**Intel® 82371AB PIIX4,
Intel® 82371EB PIIX4E,
Intel® 82371MB PIIX4M**

Specification Update

January 2002

Document Number: **297738-017**

TD CONTROL AND STATUS (DWORD 1: 04-07h)

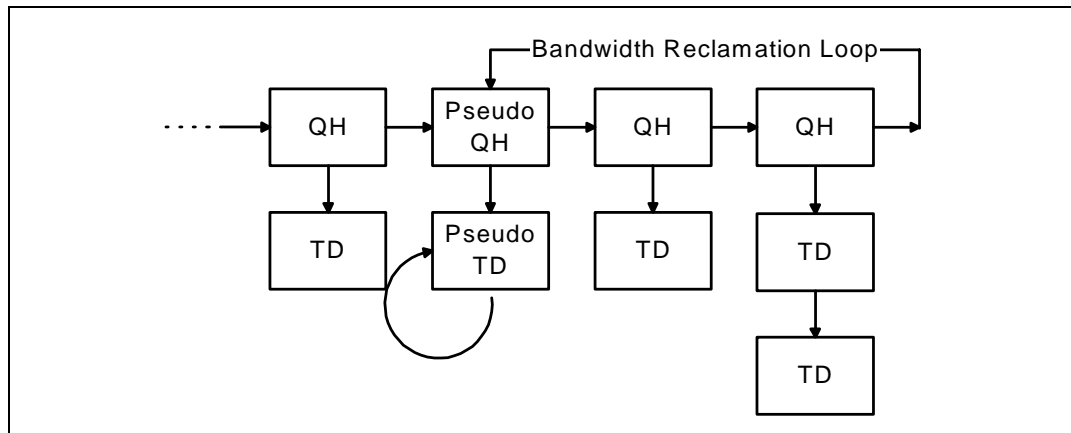
The Active status bit (bit 23) must be left unset at 0 indicating that the PIIX4/PIIX4E/PIIX4M should not execute this TD.

The Queue Head Link Pointer (QHLP=bits [31:4]) must be set to point to the pseudo TD.

Status: This erratum will not be fixed in PIIX4/PIIX4E/PIIX4M. This erratum is planned to be incorporated into the next revision of the PIIX4 datasheet as a specification change. Intel is working with Microsoft to incorporate the workaround into their UHCI driver. Microsoft will make this workaround available in the Beta 1 release of Memphis. Microsoft will provide a fix to the OSR2.1 (Detroit) release. OEMs/IHV's should contact Microsoft for the fix distribution plans.
